Technical Service Information

THM 440-T4 TCC REGULATOR PLUG PART NUMBER

Figure 1

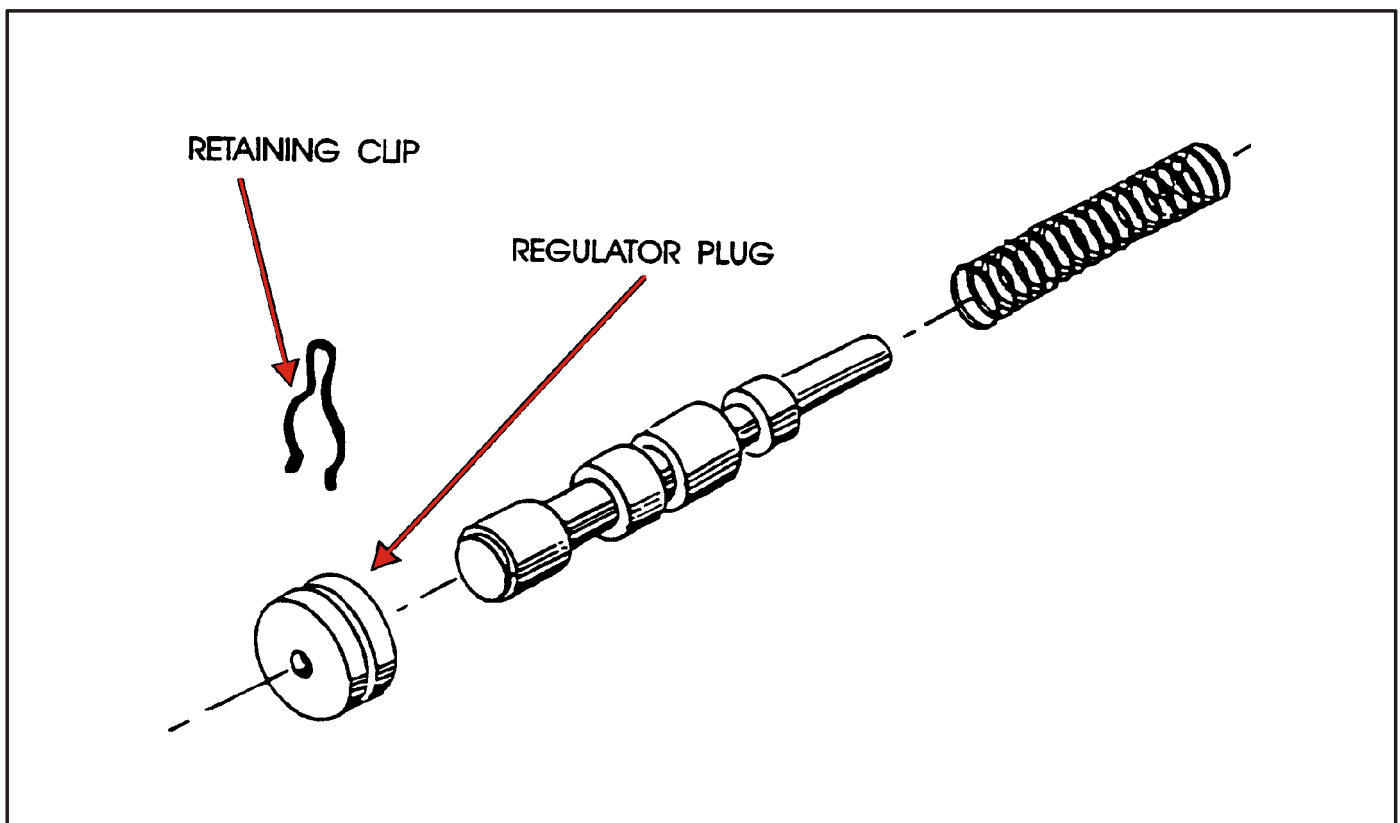
- COMPLAINT:** When installing SGSF-440 converter clutch regulator valve spring, as shown in A TSG Bulletin # 88-45, removal of the aluminum valve plug proves to be so difficult that destruction of the plug is necessary.
- CAUSE:** The plug retaining clip can beat up against the plug and flare the plug. The retaining clip also wears and can break and further jam the plug.
- CORRECTION:** New aluminum plugs and retainers are now available from General Motors. The part number for the converter regulator plug is 8649434. The part number for the retaining clip is 8656727. (See Figure 1.)
